DEPARTMENT OF ENVIRONMENTAL MANAGEMENT  
 OFFICE OF WATER RESOURCES  
 FRESHWATER WETLANDS PROGRAM  
 APPROVED WITH CONDITIONS  
 AS SPECIFIED IN THE LETTER OF APPROVAL  
 DATED AUG 22 2008 FILE # 08-0182  
 NO CHANGES ALLOWED WITHOUT PRIOR APPROVAL.  
 APPROVED PLANS MUST BE AT CONSTRUCTION SITE.

**PROPOSED SITE ALTERATIONS**  
**Mr. Joseph A. ROSSETTI**  
 Opp. Pole #135 - WEST WRENTHAM ROAD  
 AP 50 Lot 100 - Cumberland - RI

JUN 6 2008 **SITE ALTERATION PLAN - NOTES, LOCATION MAP & DETAILS**

**SITE PLAN**  
 SCALE 1" = 40"

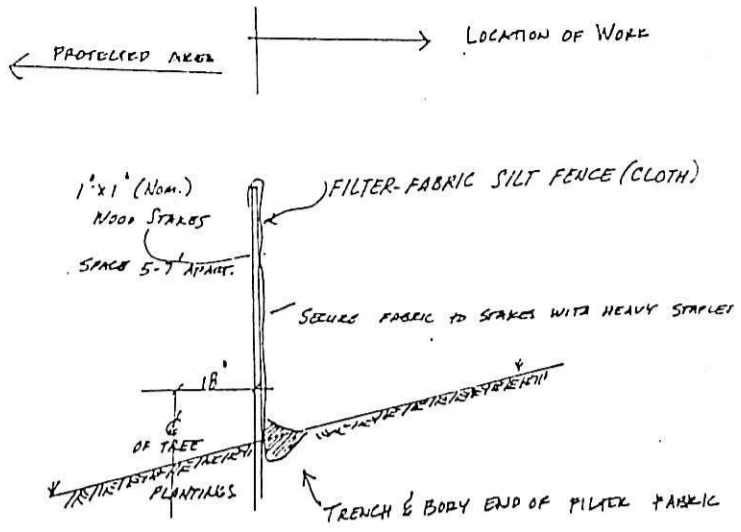
*Revised for DEM: Plant Northern White Cedar (Thuja occidentalis) saplings at end along the limits of disturbance in the locations denoted by "x". The saplings must be at least 4 feet in height and planted no greater than 7 feet apart.*
